PMSCDC Workshop Summary

PARDI MARKET PLAZA

1.2.3 Large Group Summary

Existing Concept Plans

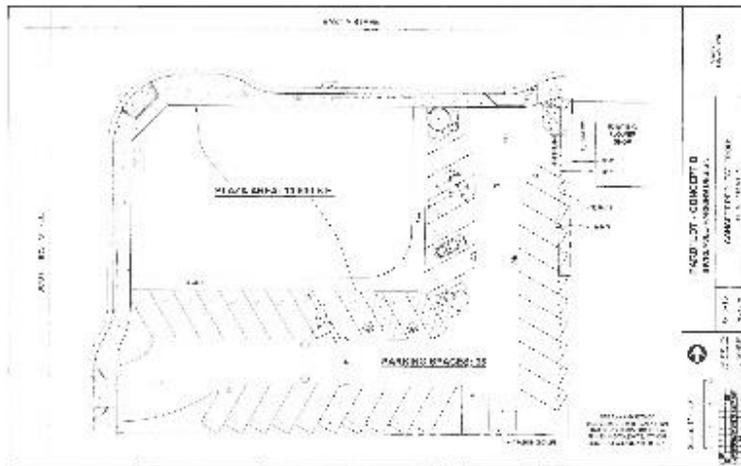
- Group 1 chose to move forward with Concept Plan B and Plan C
- Concept Plan B should have a restroom and bandstand added.
- Restroom and bandstand were desirable facilities in the final concepts.
- Parking in Concept Plan B is preferred due to City of Dixon's Downtown events (Grillin 'n 'Chillin, Tree lighting, Petting Zoo) a variety of space use (flexibility). For downtown events space and flexibility are important.
- In Concept B, the group thought the Women's Improvement Park was close by and therefore the space could have a smaller designated park area.
- In Concept C, the group liked corner location of the bandstand and thought restroom was important.
- In Concept C, the group liked the size of bandstand and trees at corner location.

- Group 4 chose to move forward with Concept Plan A and D.
- Would like to see the park have a theme, a historic period theme.
- Did not like the serpentine walls shown in Concept Plan C, liked the linear walkways proposed in Concepts A and D.
- Stage locations: Concept A best, Concept D acceptable, and did not like Concept C.
- Concept A has too many pergolas.
- Do not like use of decomposed granite (D.G.).
- Concerned about use of low seat walls (they could be the next skate park).
- Concept C has too many entry points, final concepts need “documented” entries.
- Like 20 parking spaces as the amount of parking.
- Like trees, like clock tower, and offset the pergolas.

- In Concept D, the group would like the final master plan to explore a bandstand location slightly to the southwest.
- In Concept A, take bocce court out of the design.

Concept Plans C and D

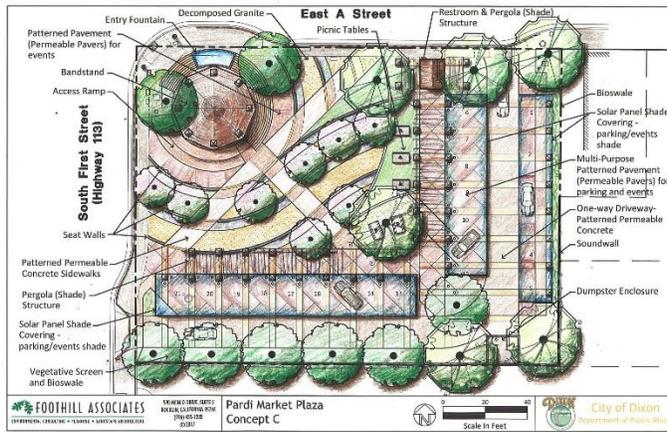
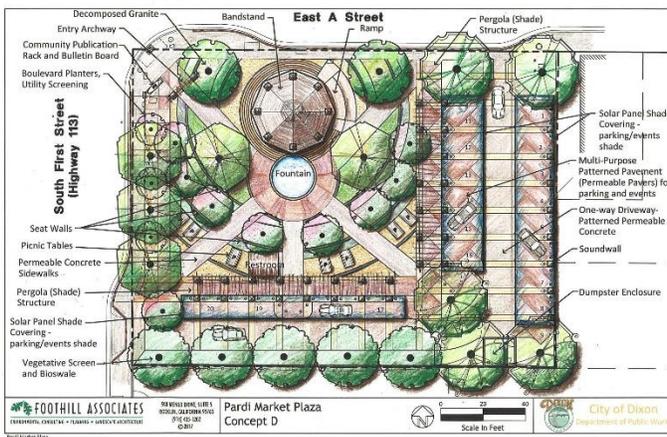
- Group 2 chose Concept D first, followed by Concept C.
- The group would like to move the bandstand towards the southeast corner.
- Easy for band (Dixon HS Jazz Band), more events (Wine Stroll, Beer Walk), and crowd spreads out towards HWY 113.
- The ideal/optimum stage size for events at this site is 20'x35'. This could be accomplished by allowing space for temporary/portable adapters to enlarge the bandstand space for events. Explore/investigate ways to achieve optimum stage size.
- Add "wow" factor on corner, e.g. clocktower.
- Add more large canopy/shade trees (e.g. sycamore tree).
- Include/keep solar over parking and add solar to bandstand.
- Remove fountain, possible location of pergola in center.
- Liked the seat walls shown in the plans.

- Group 3 chose to move forward with Concept Plan C and D.
- Would like to remove fountains from designs and prefer another type of center focal point such as a clock tower.
- Like the parking in the back and out of sight.
- Expressed concern about restroom/maintenance of restroom. Would prefer no restroom.
- Would like "clean" trees such as a sycamore used.
- Would prefer bandstand location in back.

- Important to have Farmer's Market space, similar to Davis, like Concept C for this use.
- In Concept C liked the location of the bandstand on the corner (so it is further away from the residents to the south and east).

- The design of Concept C is too modern, the seat walls are too contemporary for site, and not historic. Would prefer or like to see brick used.

- Group 6 chose to move forward with Concept Plan D or none of the above (commercial development).
- Liked Concept D if it had the bandstand at southeast corner.
- Would like to have decomposed granite stabilized with cement.
- The group felt parking was not needed in the design per the Parking Utilization Study and would like to have Women's Improvement Park revitalized for increased public use (a park is not needed).

- Concept C feels like a "squirrely" mess. Symmetrical design of other concepts was more appealing to the group.
